SUBJECT: COMANCHE PEAK STEAM ELECTRIC STATION
DOCKET NOS. 50-445 AND 50-446
RESPONSE TO REQUEST FOR ADDITIONAL INFORMATION REGARDING SPENT
FUEL POOL CRITICALITY LICENSE AMENDMENT REQUEST
(TAC NOS. MD8417 AND MD8418)

**Response to NRC Request for Additional Information
Question 26
(Non-Proprietary)**

Revised Markup of Technical Specification pages

Figure 3.7.17-1
Minimum Required Fuel Assembly Burnup versus Initial ²³⁵U Enrichment for the
"4-out-of-4" Storage Configuration

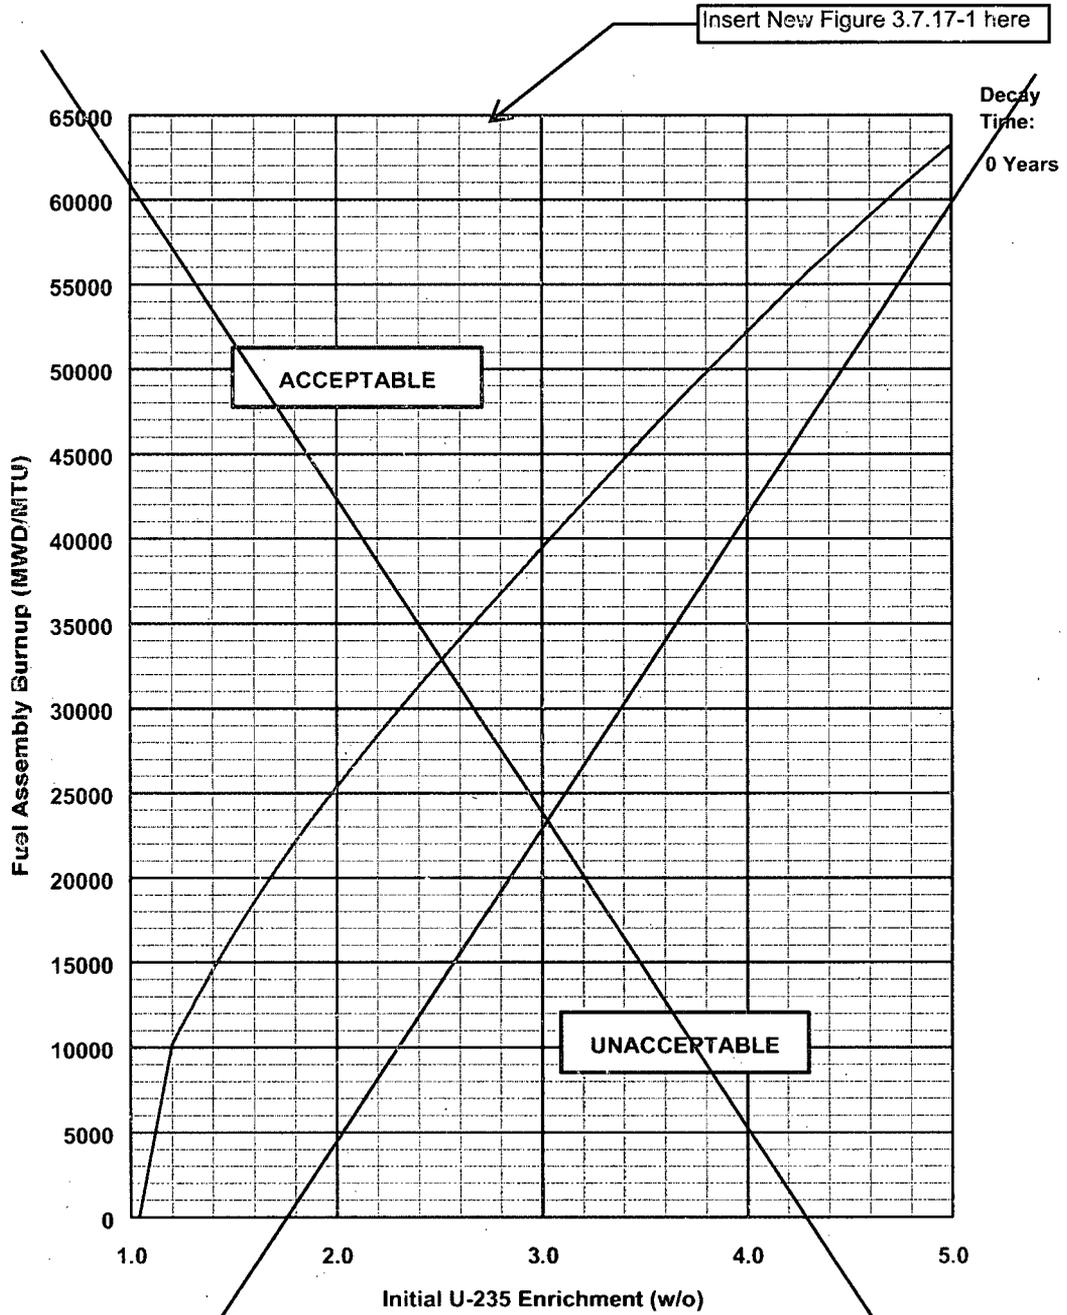
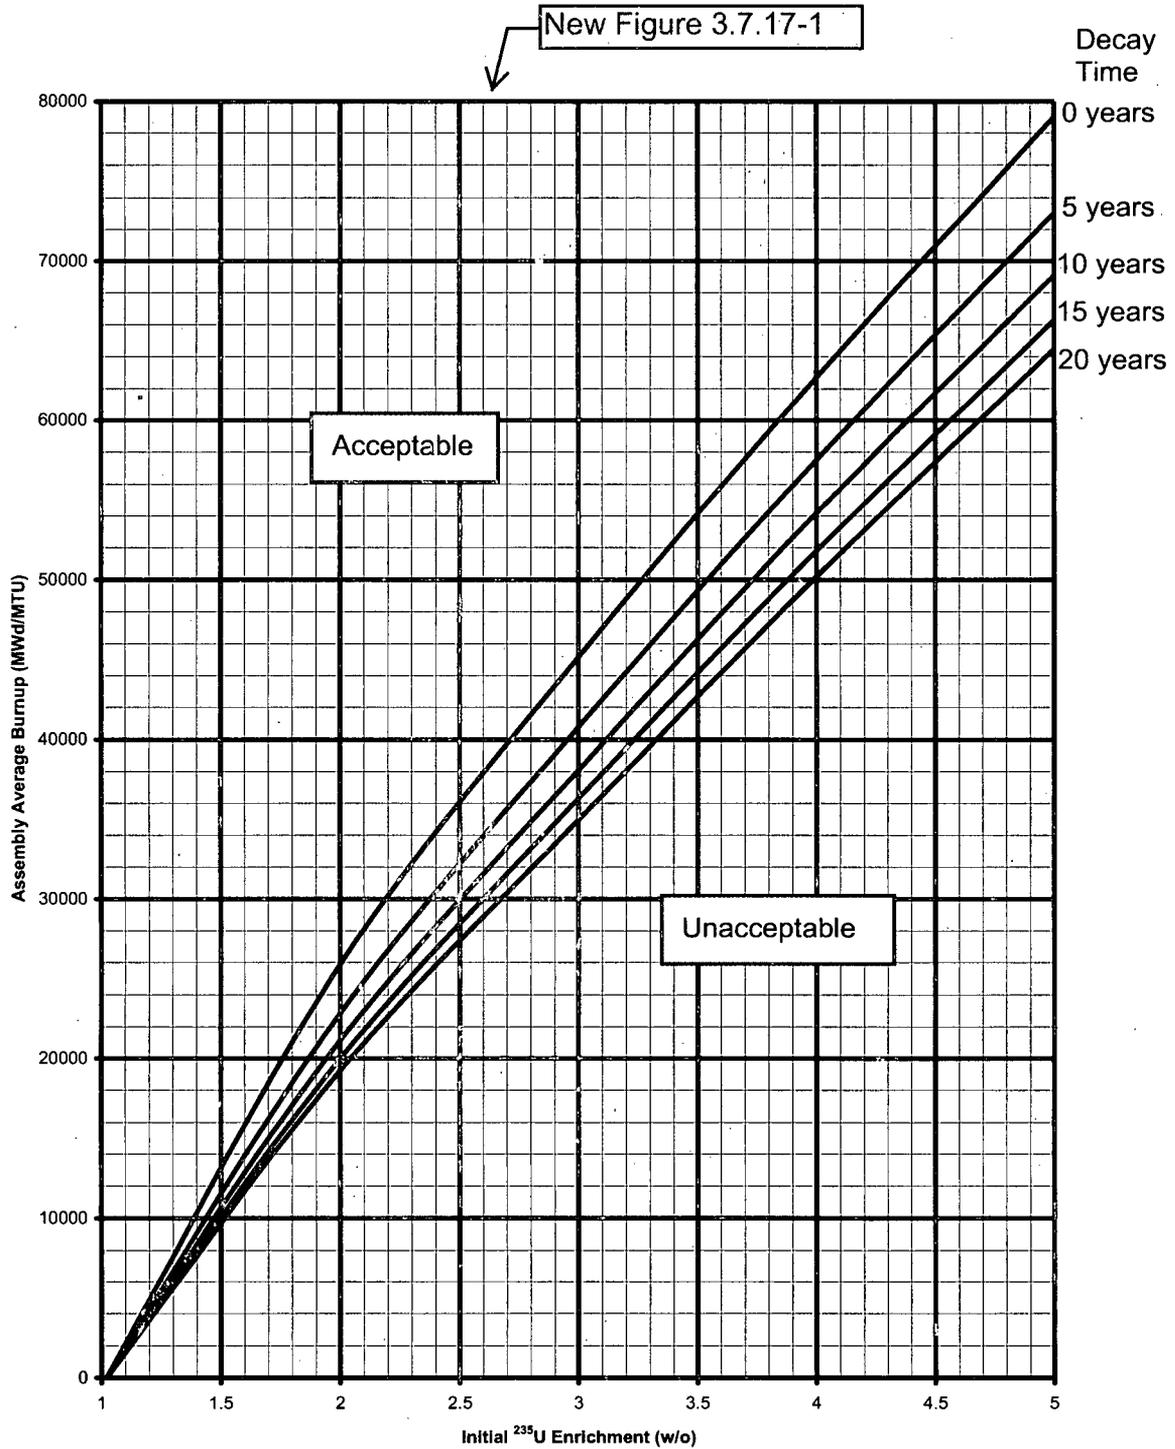
Attachment 3 contains updated Technical Specification Markups for the figures in Technical Specification 3.7.17 reflecting the revised analysis. These updated figures should replace the original curves provided in LAR-07-004. In addition, the design basis features section of the Technical Specifications has been included in the Markup, reflecting the renumbering of the figures in Technical Specification 3.7.17 for acceptable spent fuel storage locations.
